ADDENDUM NO. 2

San Antonio Water System

Project Name: **Olmos Basin Central Watershed Sewer Relief Line (C-3), Reaches 1 to 4**

Project No.: **08-2512**

SHEET NO. **C-205**
25 OF 123

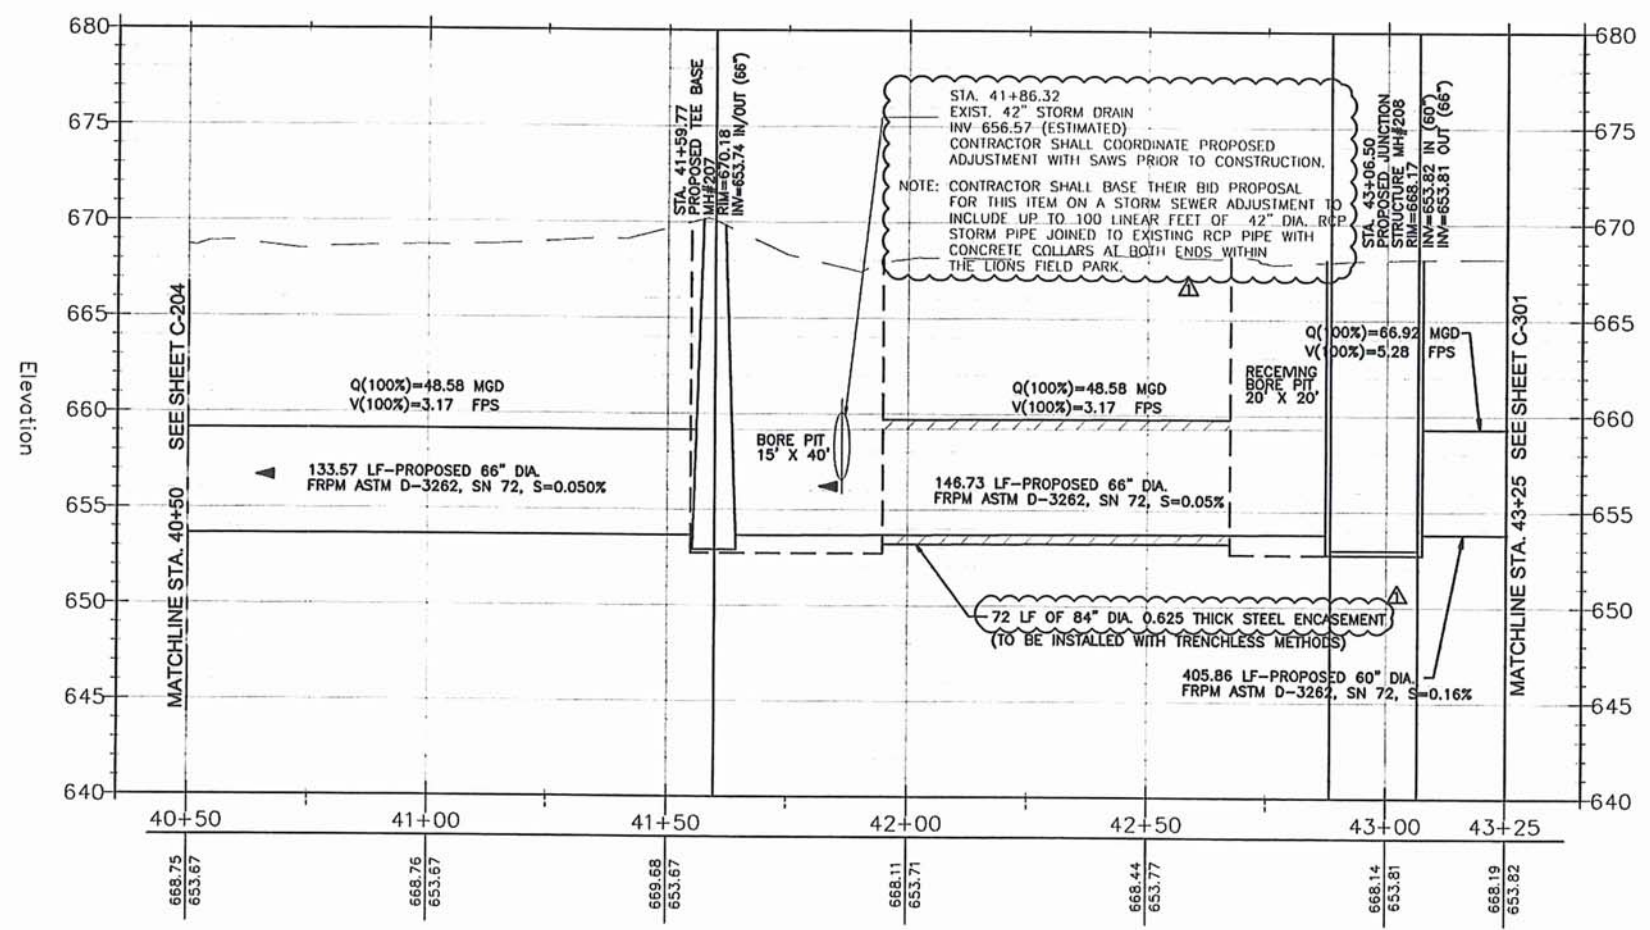
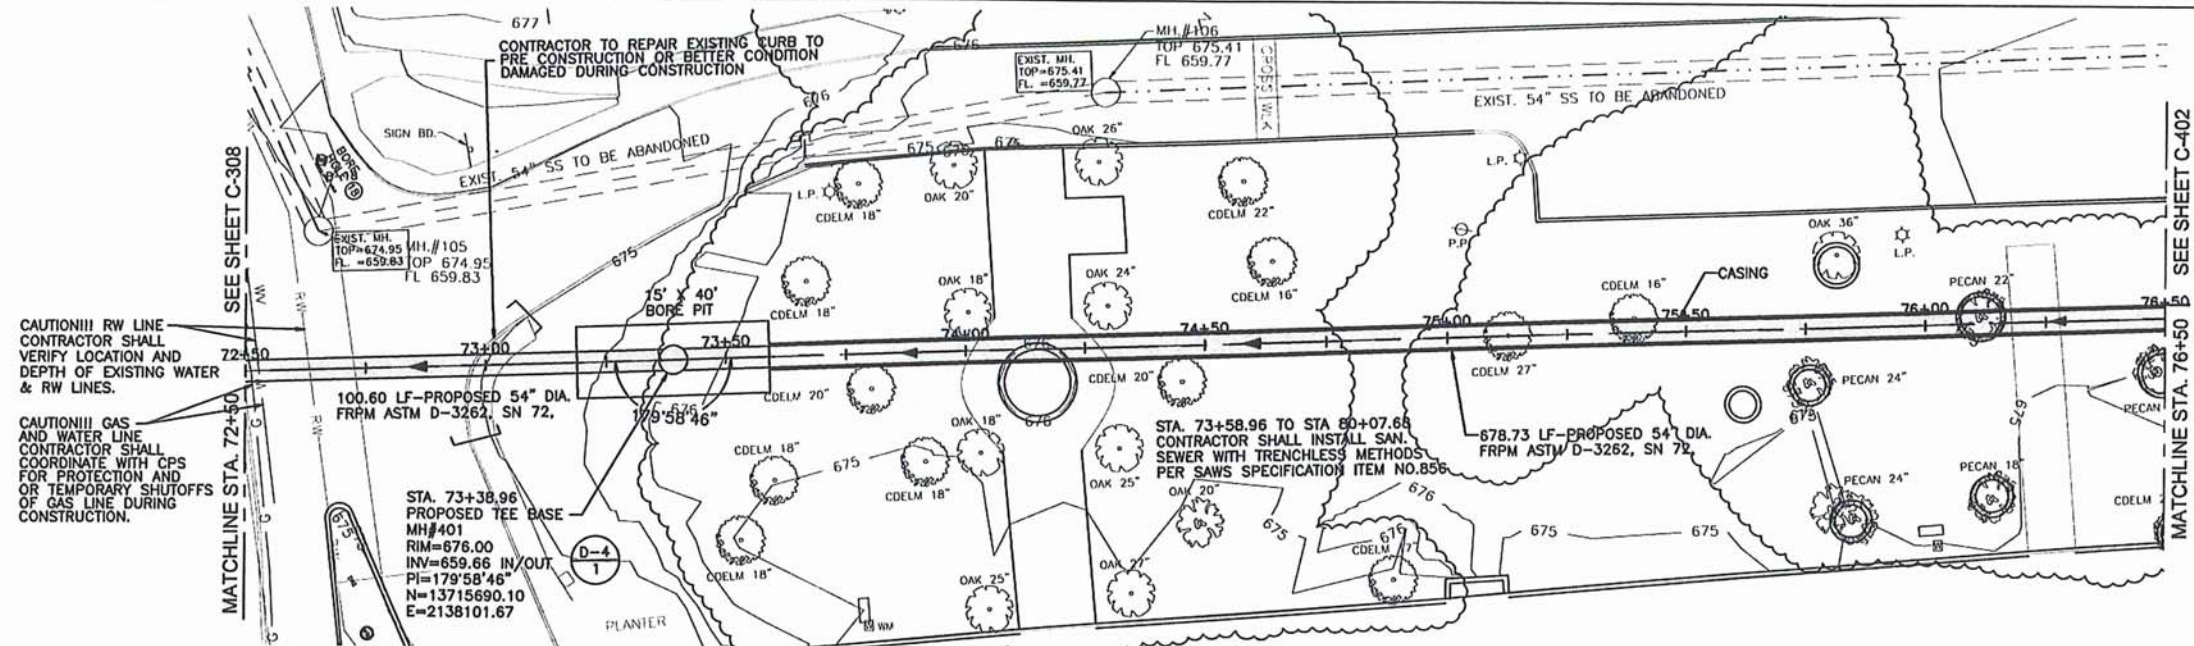
Item 7: Sheet C-205 – Remove and replace Sheet C-205 with the revised Sheet C-205 attached to this addendum. Revisions include:

- a) On profile view, delete callout note that reads: “137.27 LF OF 84” STEEL ENCASEMENT” and replace with: “72 LF 84” DIA., 0.625” THICK STEEL ENCASEMENT”
- b) Delete callout on existing storm drain pipe that reads:
“STA. 41+86.32
EXIST. 42” STORM DRAIN
(STORM DRAIN TO BE REROUTED TO 10’X6’ SBC)
INV 656.57
CONTRACTOR SHALL COORDINATE PROPOSED
RELOCATION WITH OWNER PRIOR TO CONSTRUCTION.”

Q13: On Plan Sheet No. C-205, there is an 84" Trenchless crossing with a stated length of 132.27 LF. It appears to us that the 84" Trenchless crossing is only 72 LF in length. What is the required length of this casing?

Q25: Sheet C-205 contains a note on the profile view directing the contractor to reroute the 42" storm drain pipe to a 10' x 6' single box culvert. Please provide plan and profile for this operation.

Q35: On Plan Sheet C-205, Sta. 41+86, Contractor is to coordinate with Owner the rerouting of an existing 42" Storm Drain Pipe to a 10' x 6' Single Box Culvert (SBC). We are assuming the referenced SBC is located on Plan Sheet C-204 at Sta. 38+15. There is no Bid Item or Plan Sheet Details for rerouting the 42" Storm Drain Pipe and we are assuming its relocation will be performed by others. Is this correct?

Refer to Addendum No. 2 – B. Drawing Revision, Item 7.

Revised Bid Proposal includes pay item for the storm sewer adjustment. Refer to Addendum item related to Sheet C-205 (Addendum No. 2 – B. Drawing Revision, Item 7).

SHEET NO. **C-402**
 35 OF 123

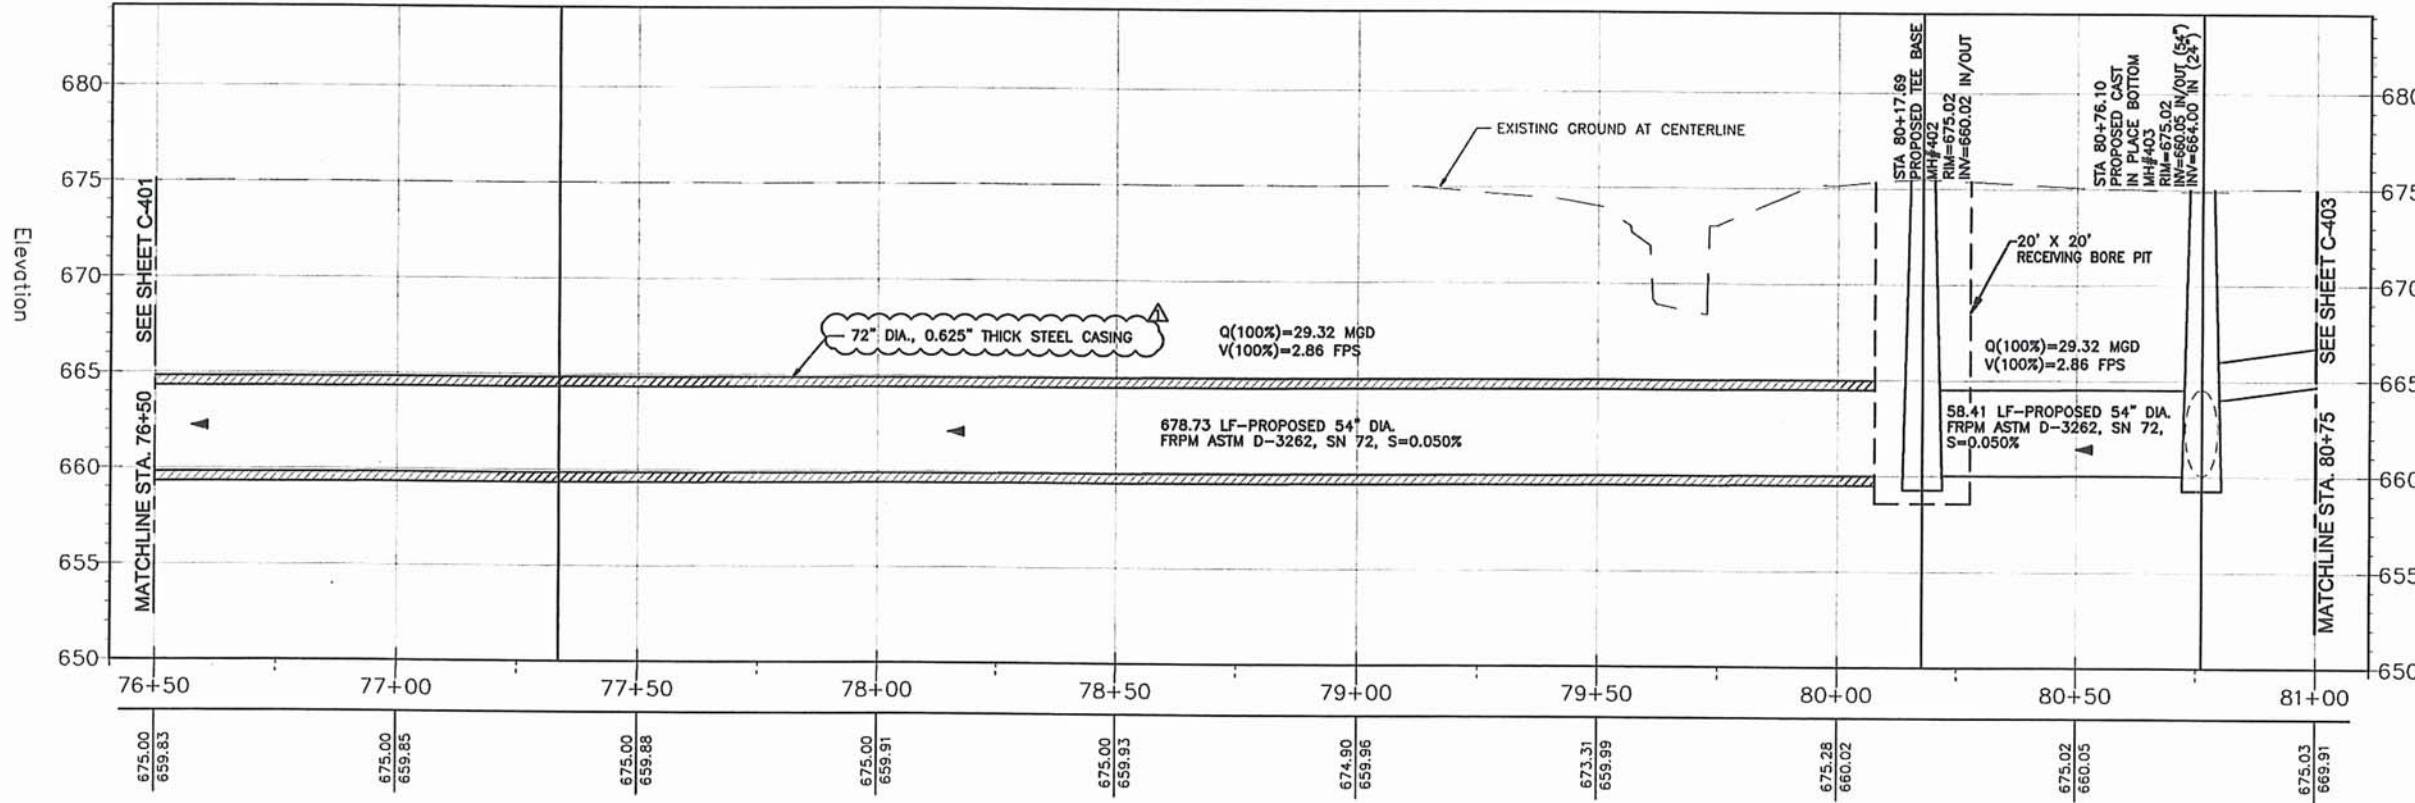
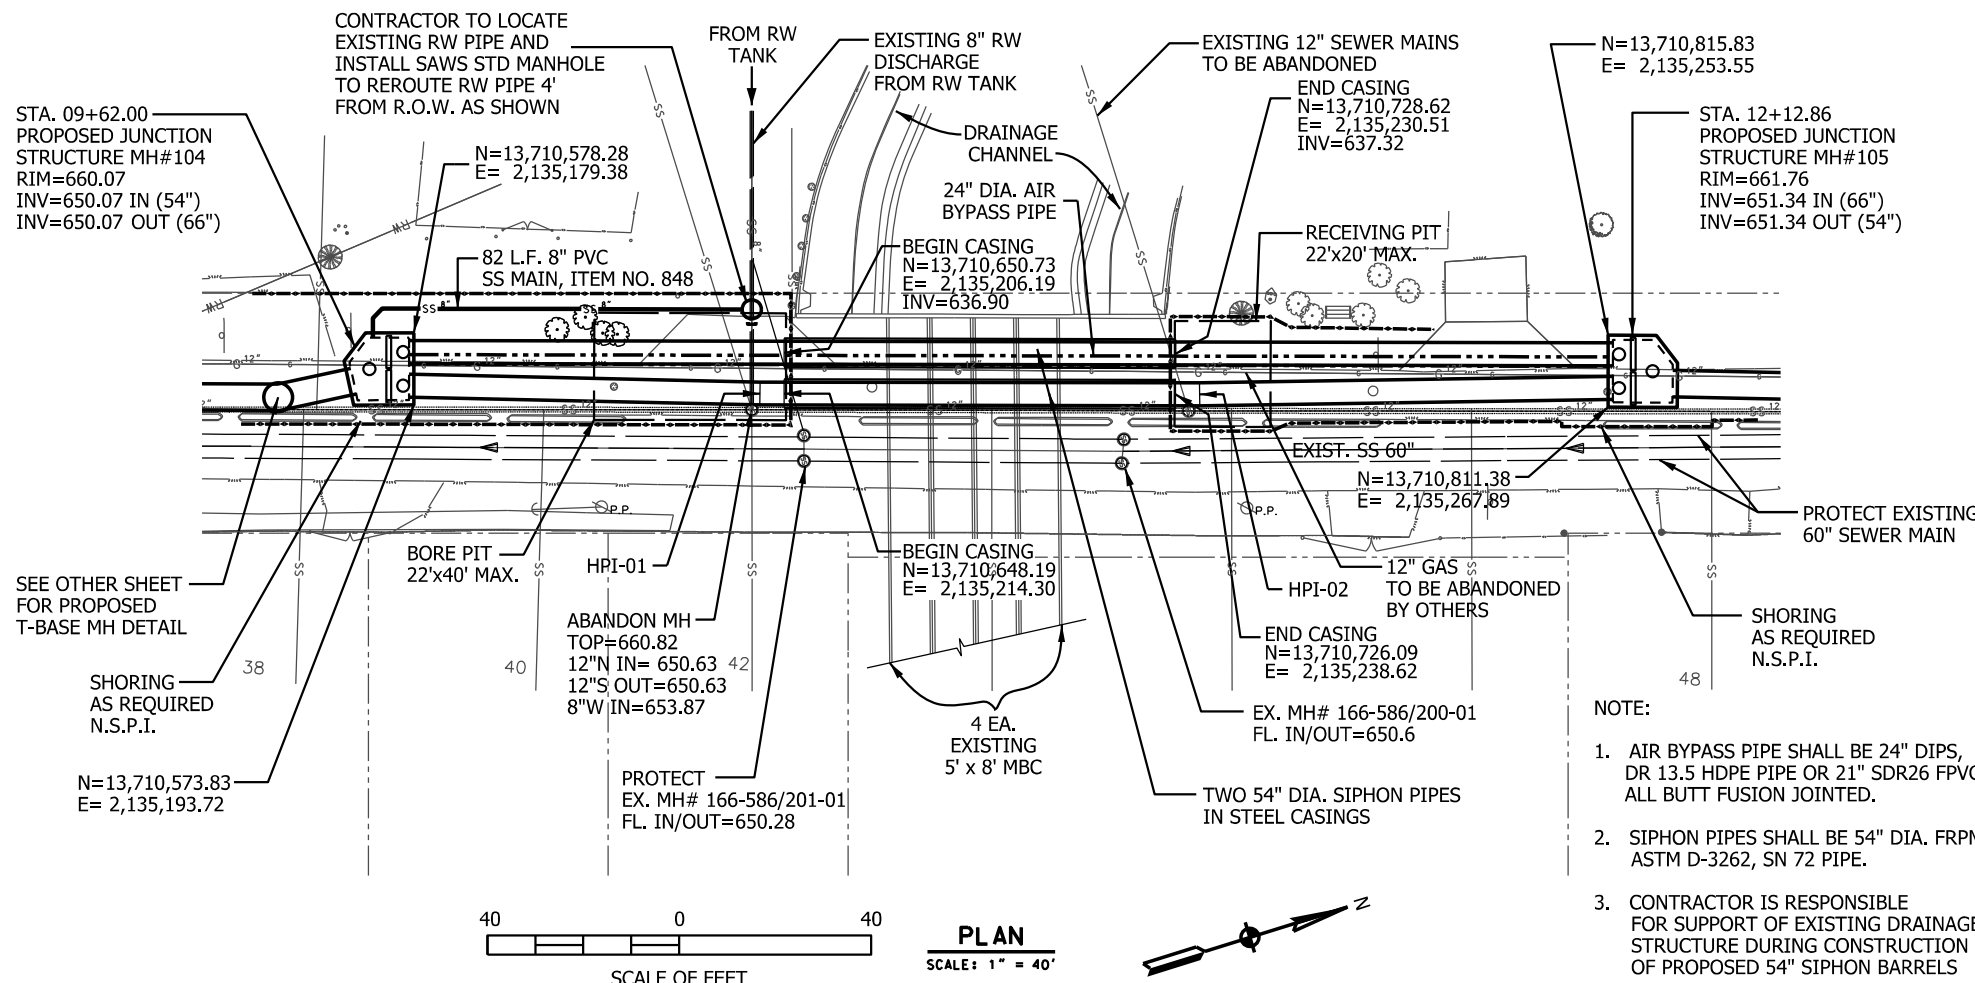
Item 8: Sheet C-401 and C-402 – Remove and replace Sheet C-401 and C-402 with the revised Sheet C-401 and C-402 attached to this addendum. Revisions include:

- a) On profile view, add note to 72” steel encasement label to indicate steel casing thickness: “72” DIA., 0.625” THICK STEEL CASING”

Q4: Bid Item No. 30 – Junction Structure MH#404. We could not locate this structure on Plan/Profile Drawings or specific detail drawings. Is this a required structure which is to be part of this contract?

This bid item was intended for Junction Structure MH# 403, shown on Sheet C-402 at Sta. 80+76.10. The bid proposal item will be revised to refer to MH# 403 (and not MH #404).
